PLANT NAME: TURKEY PT # 3 & 4

Re: Turkey Point Units 3 and 4  
Docket Nos. 50-250 and 50-251  
Steam Generator Tube Integrity  
Supplemental Information

On December 10, 1976, we received a request for information (12 questions) concerning steam generator tube integrity. The answers to Questions 1, 3 through 6, and 8 through 12 were submitted on December 22, 1976 (L-76-432). The answers to questions 2 and 7, and revised answers to questions 8 and 9, are attached.

FIGURE 2-1  
RELATIVE WALL THICKNESS VS. ANGLE  
ROWS 1, 2, 3

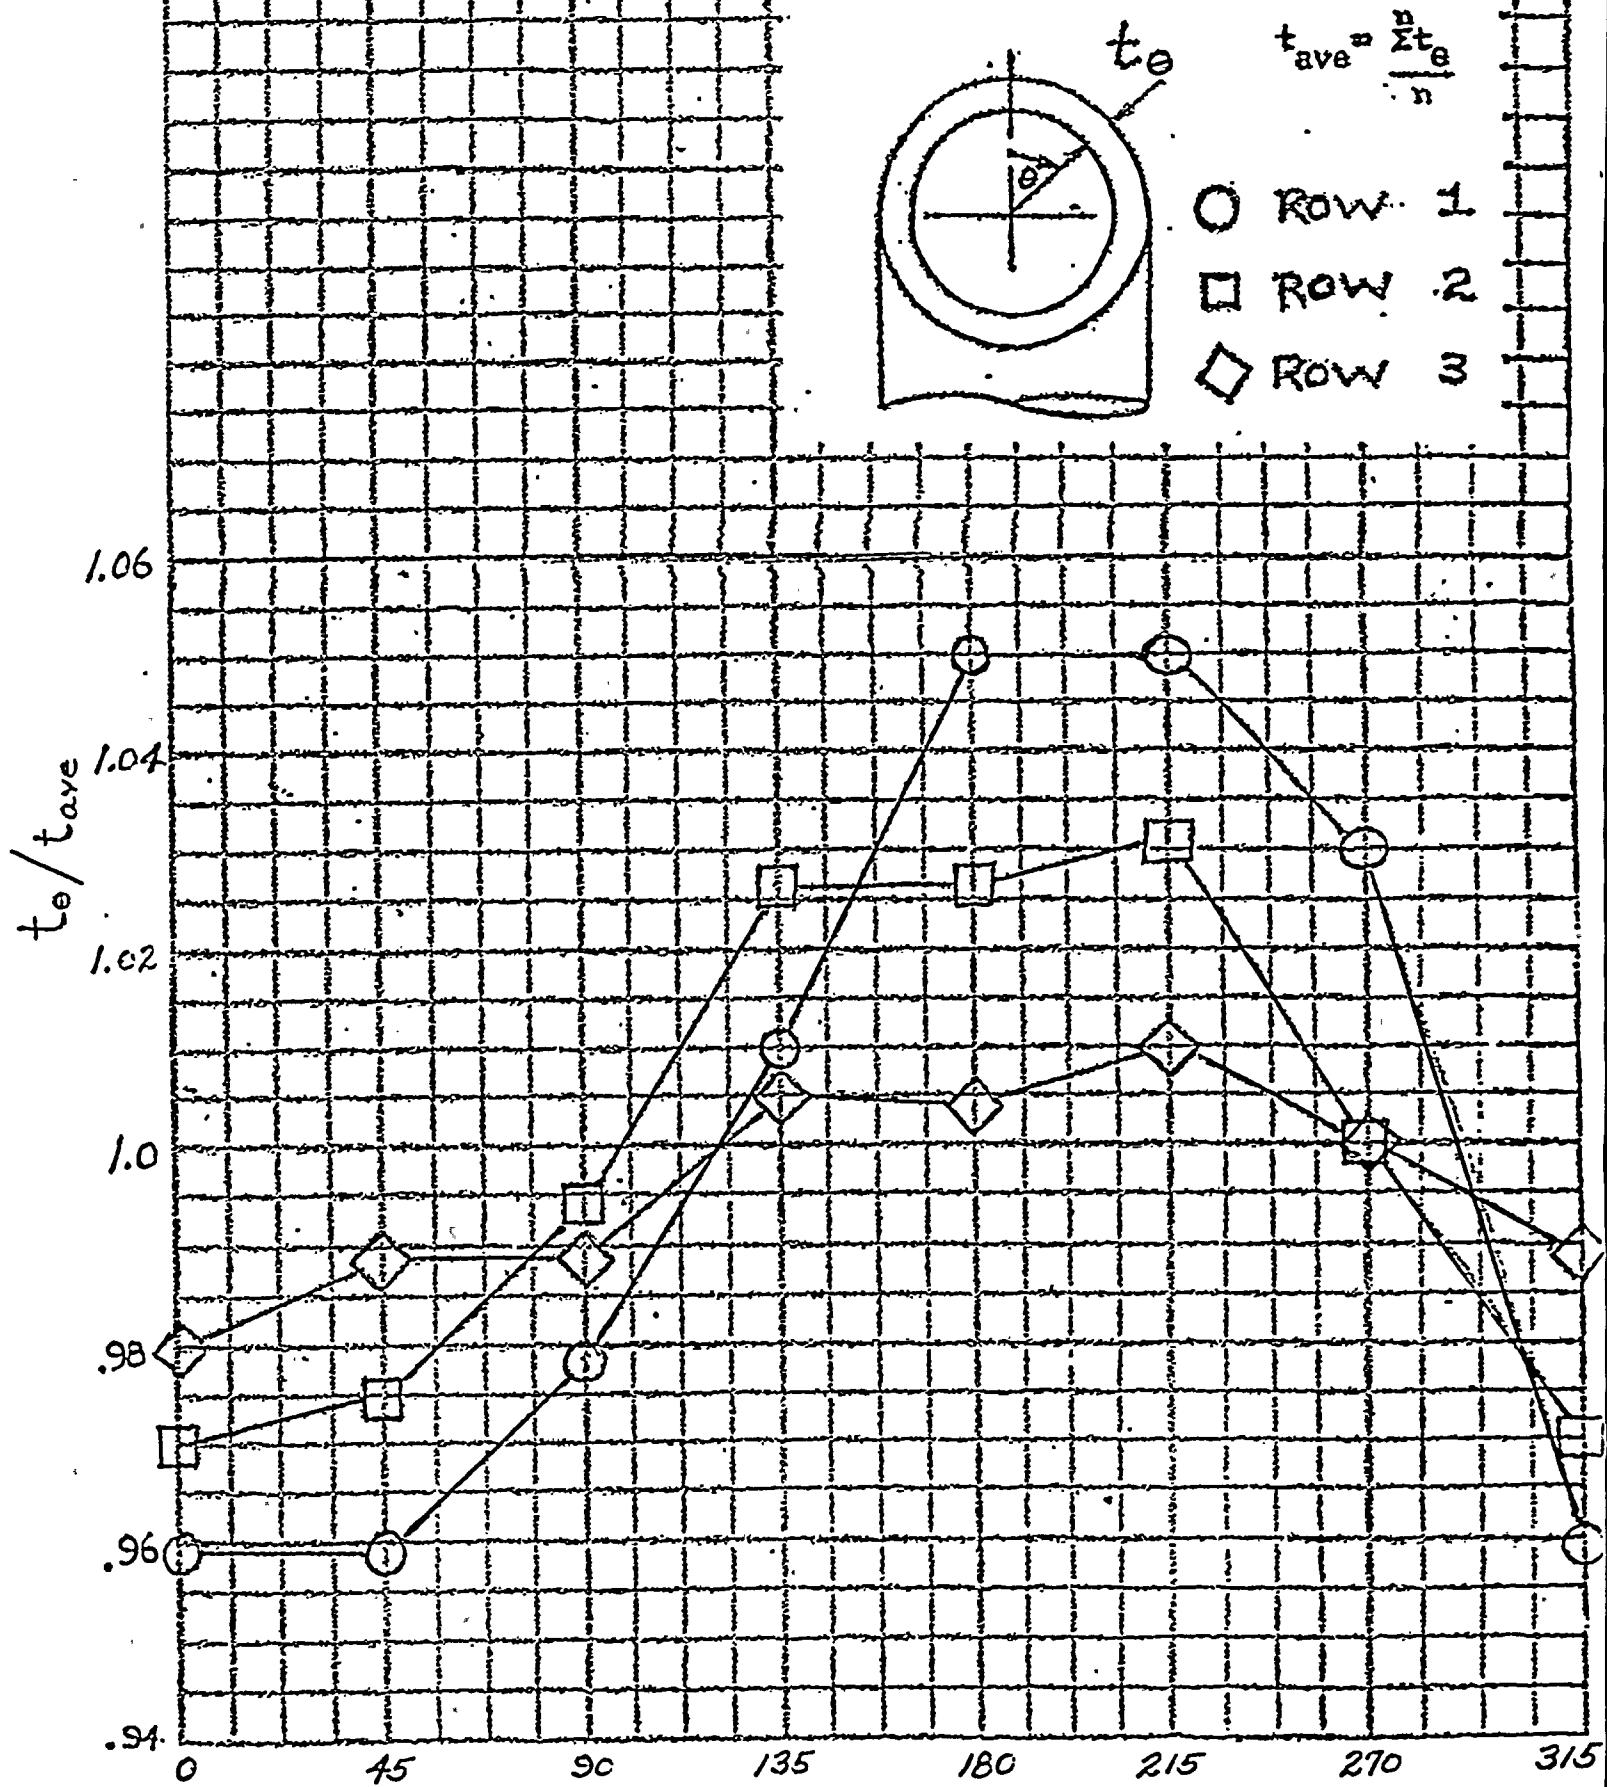
QUESTION #2 Estimate the error band and specify the degree of confidence in the strain data provided in response to question 1, i.e. specify the tolerances in the manufacturing strain.

3. Since the tube wall is always thinned at the extrados, the ratio of  $t_\theta/t_{ave}$  taken from mill data (Figure 2-1) will be used in the strain tolerance calculations. From Figure 2-1 the tolerance on this quantity is less than  $\pm .01$ . Therefore,

$$\epsilon_r \text{ max.} = \frac{.95(t_{ave}) - t_{ave}}{t_{ave}} = -.050 \text{ in/in}$$

$$\epsilon_r \text{ min.} = \frac{.97(t_{ave}) - t_{ave}}{t_{ave}} = -.030 \text{ in/in}$$
